Addendum

Final Environmental Impact Report
[State Clearinghouse No. 2019049020]

**Los Angeles International Airport (LAX)
Airfield and Terminal Modernization Project**

December 2024

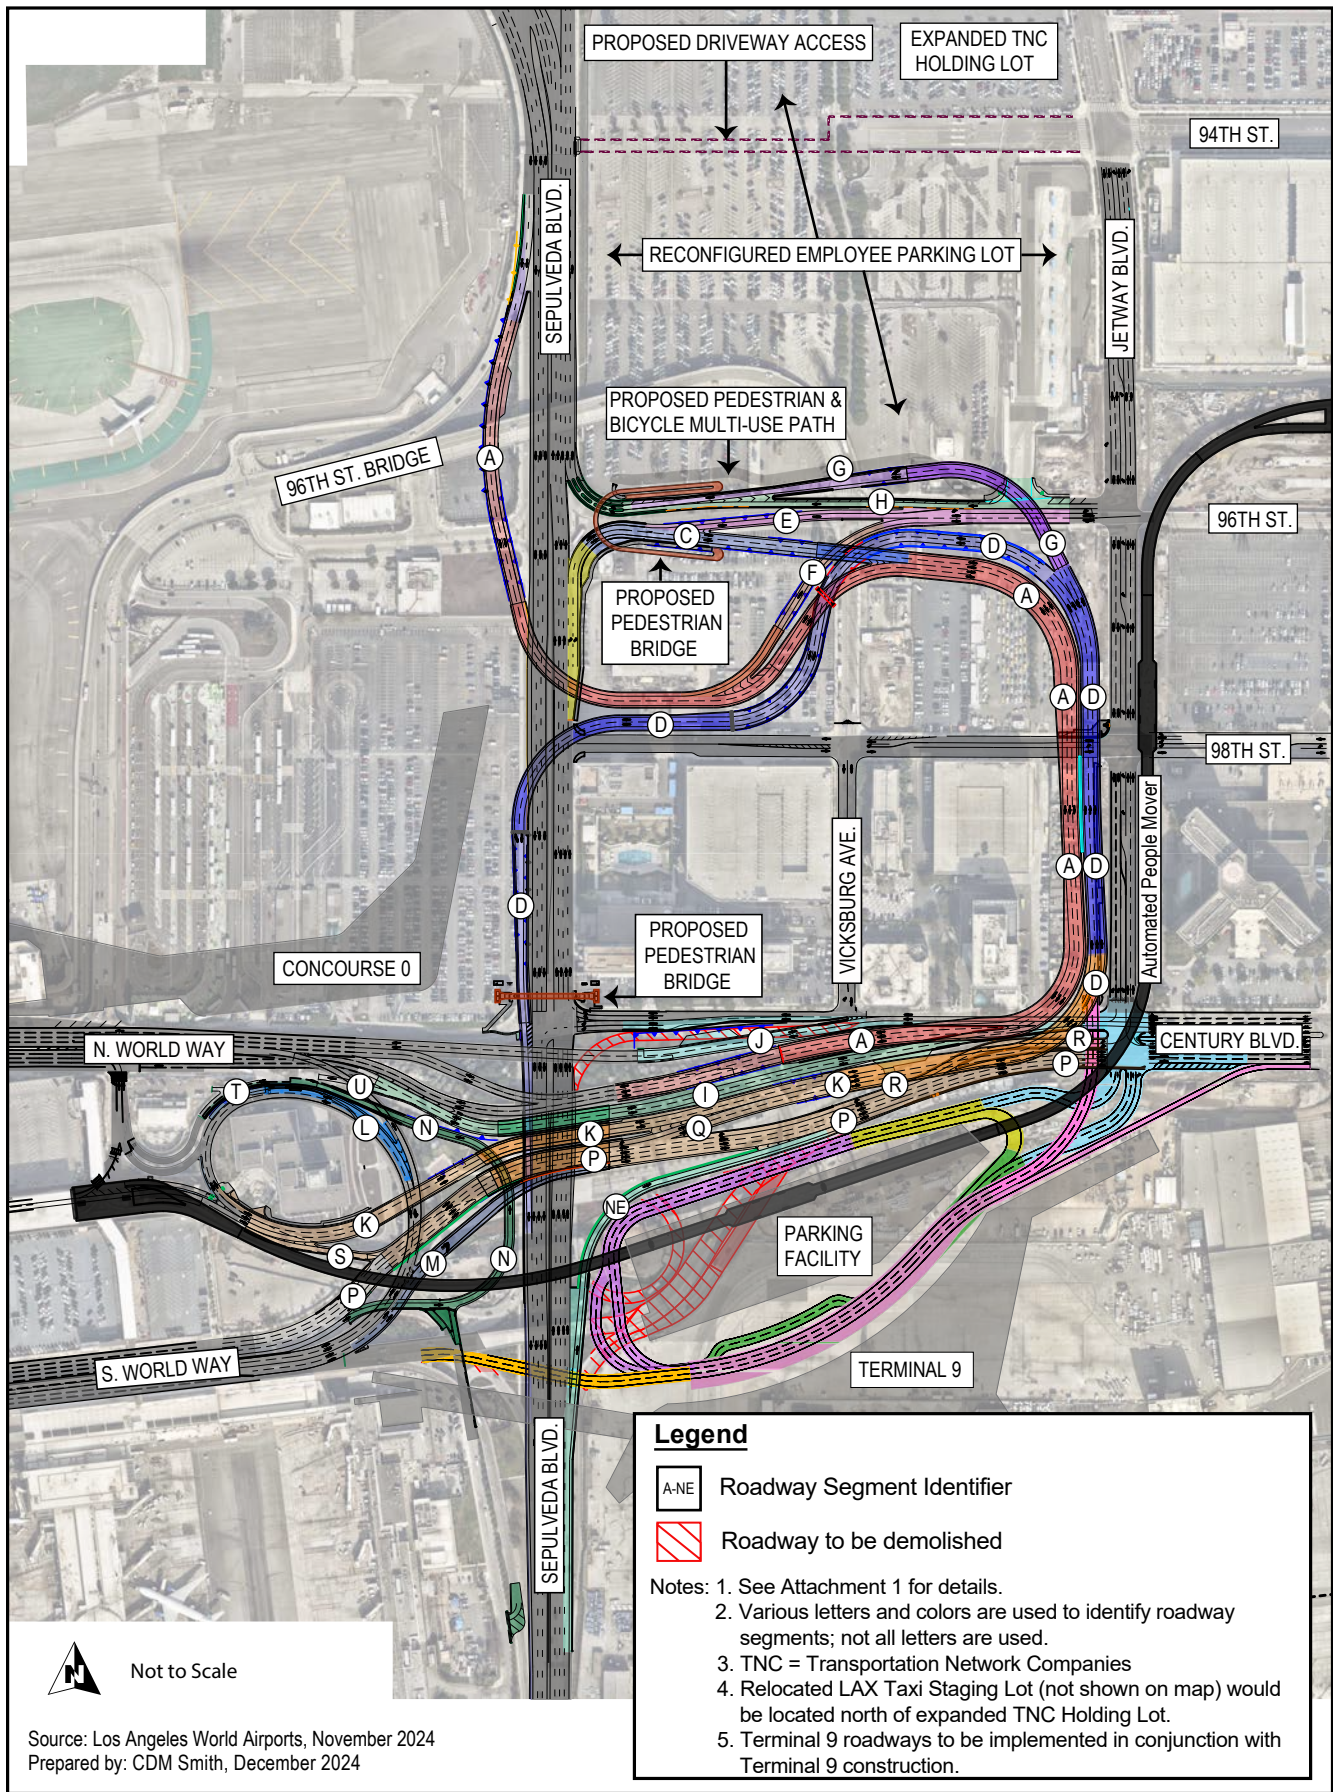
- Realignment of planned road segments and ramps, and modifications to planned new lanes
- Elimination of the originally planned traffic signals at the intersection of Sepulveda Boulevard and 96th street to maintain the existing free flow traffic conditions on Sepulveda Boulevard at this intersection
- Two new pedestrian overcrossing bridges, including a pedestrian bridge crossing 96th Street east of Sepulveda Boulevard and a pedestrian bridge crossing Sepulveda Boulevard north of Century Boulevard
- Easement and property acquisition refinements

Figure 4 shows the overall Proposed Roadway System Refinements. **Attachment 1** provides a detailed breakdown of the individual Proposed Roadway System refinement components. The following section of this Addendum describes these key Proposed Roadway System Refinements.

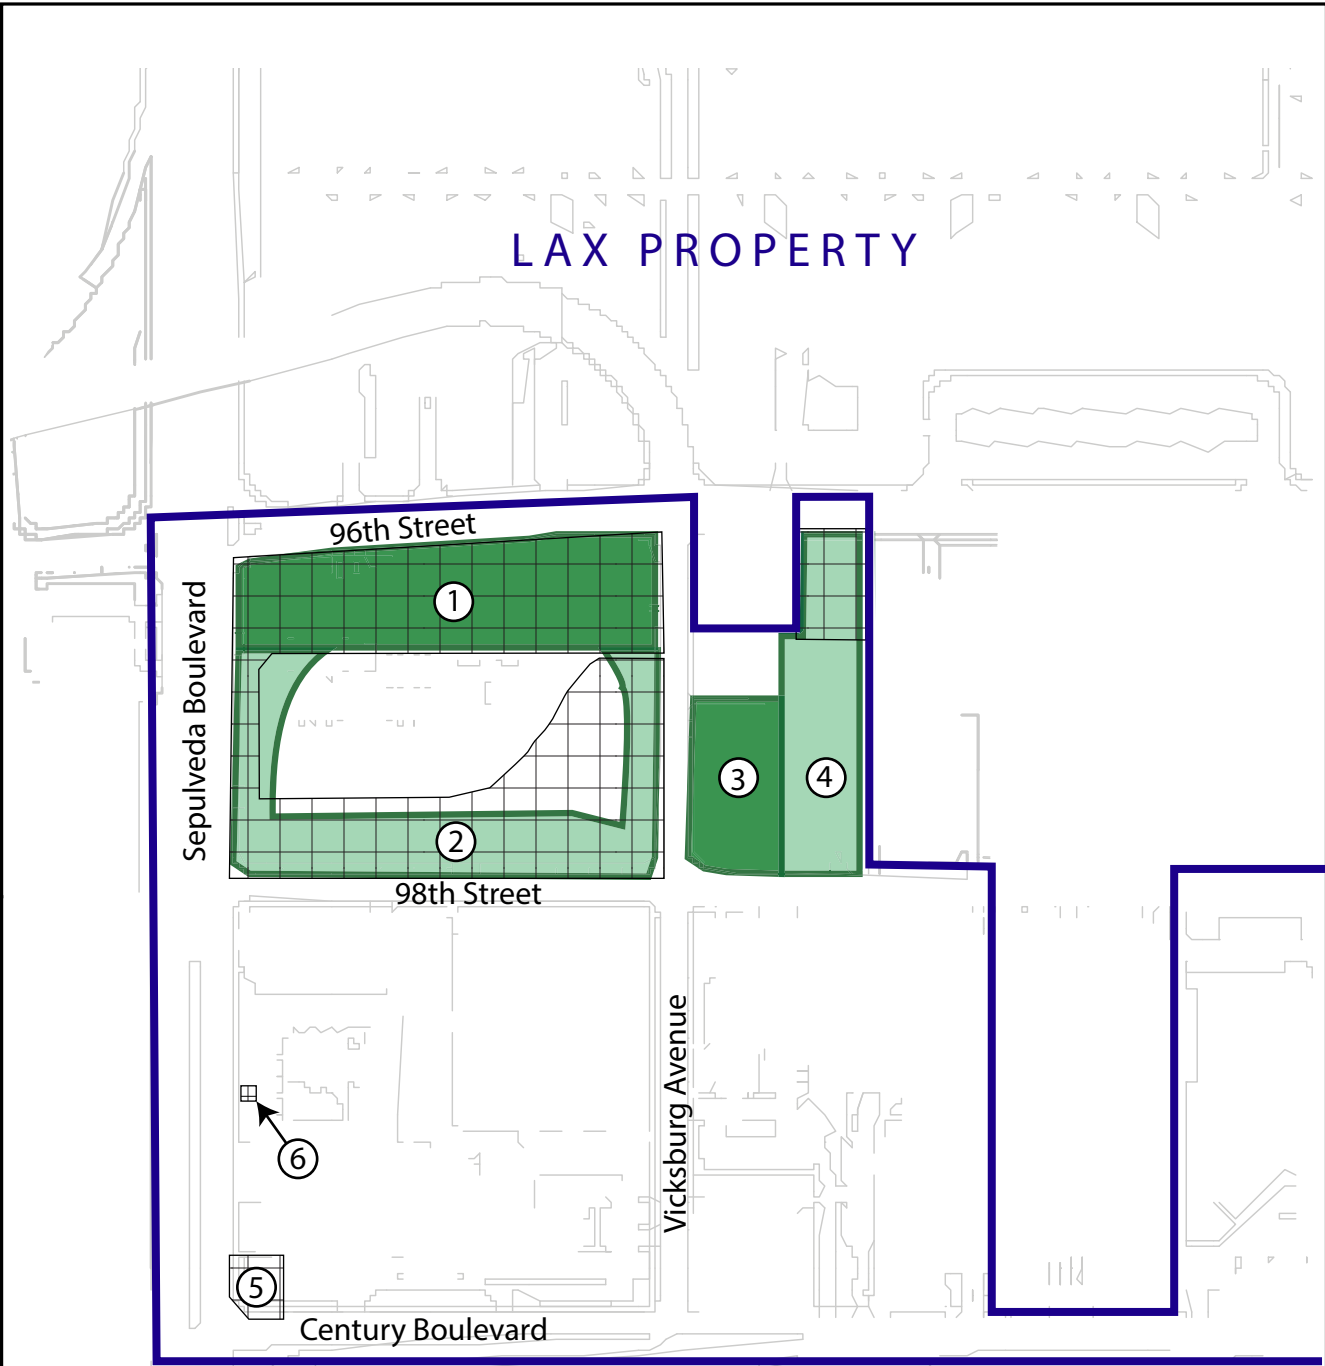
This section describes the key refinements that are generally located north of 98th Street and between Sepulveda Boulevard and Jetway Boulevard. Refinements in this area include roadway alignments, easements and property acquisitions, and street closures/modifications.

The realigned Segments A and D (as well as the realignment of Segment F discussed further below) would require additional property acquisition of the LACCD property located on the northeast corner of 98th Street and Sepulveda Boulevard (see Attachment 1, Figure 1A, Image 2). Property acquisition requirements under the Approved Roadway System as compared to the Proposed Roadway System Refinements are identified in **Table 1** (in Section 3.4 below) and on **Figure 5**. With the realignment, the Segment A roadway would be closer to the Former Aircraft School Building located on the LACCD property than under the Approved Roadway System (approximately 38 feet to the south as compared to 65 feet, and approximately 90 feet to the east as compared to 327 feet), although the proposed roadway improvements to the west would be farther from the Aircraft School Building (approximately 70 feet west as compared to 45 feet).

In addition to the alignment changes described above, the originally-planned connection from northbound Segment G to eastbound 96th Street (via Segment F), which would have also provided access to Jetway Boulevard, would be eliminated (see Attachment 1, Figure 1A, Image 3; eastbound access to 96th Street under the Proposed Roadway System Refinements is discussed below). Under the Proposed Roadway System Refinements, outbound access from the CTA to Jetway Boulevard would be provided by Century Boulevard via Segments P and R.
